MEMORANDUM

FROM: Chuck Lesniak, Environmental Officer
Watershed Protection Department

DATE: January 11, 2013

SUBJECT: Covered Bridge PUD C814-2012-0055

Figure 1

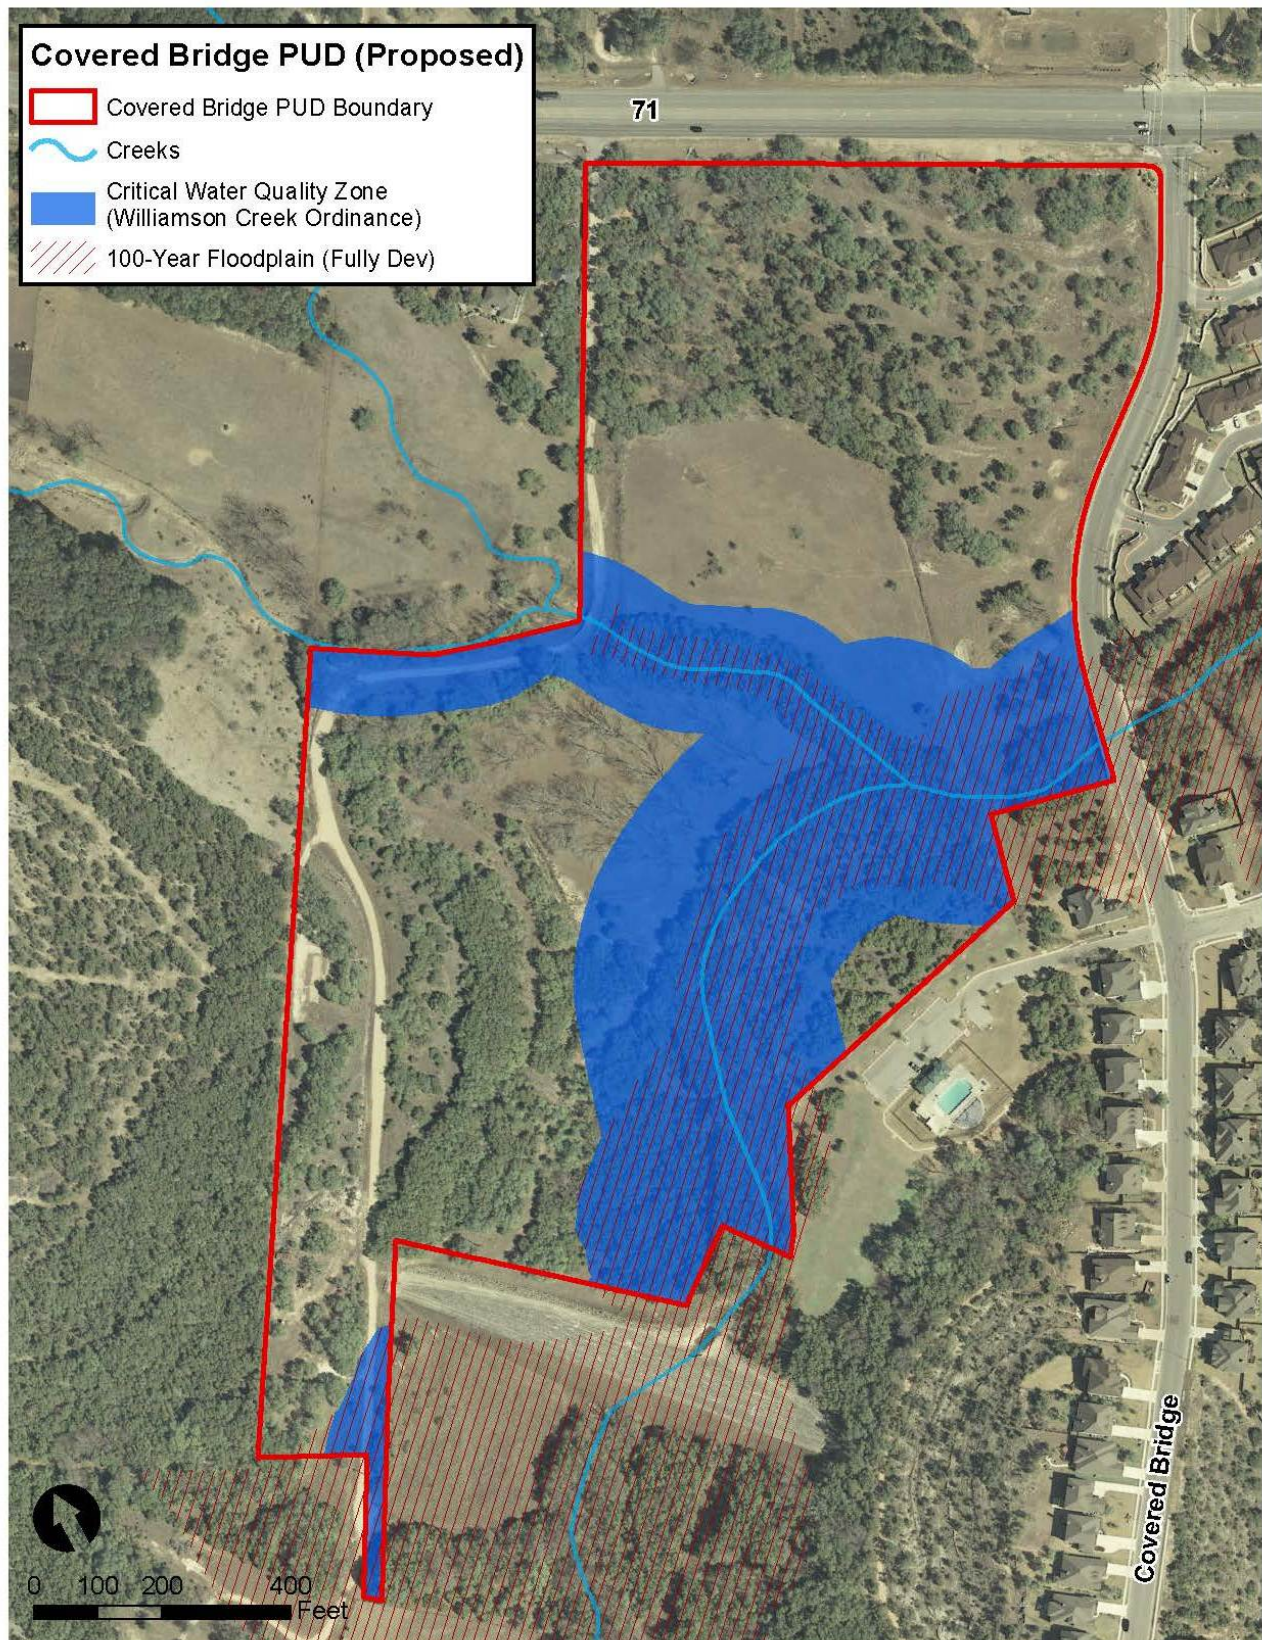
The junction of the 2 main stems of the headwaters of Williamson Creek occurs within the middle of the site, therefore there are extensive Critical Water Quality Zone (CWQZ) setbacks associated with all 4 tracts as seen in Figure 1. Under the WCO only roads are allowed in the CWQZ and no development is allowed in the CWQZ under the SOS ordinance. The PUD proposed development in the CWQZ will be limited to re-irrigation areas (tract 3) and a biofiltration pond (tract 1). The re-irrigation area in the CWQZ will not be allowed within 50 feet of the centerline of the classified waterways in the PUD.

- The CWQZ for tracts 1-3 should be calculated using the WCO or current code in lieu of that shown on the plat which appears to have been calculated incorrectly

- Remove the restrictive covenant from all PUD properties so that any future development or redevelopment beyond that proposed in the PUD will comply with regulations in effect at the time of development.
- Comply with all current tree protection regulations.
- Install rainwater harvesting to the maximum extent practicable on tract 1 and use rainwater to irrigate landscaping.
- Comply with City landscape ordinance, particularly the innovative water management components.
- Amend the plat to remove the incorrectly defined CWQZ.
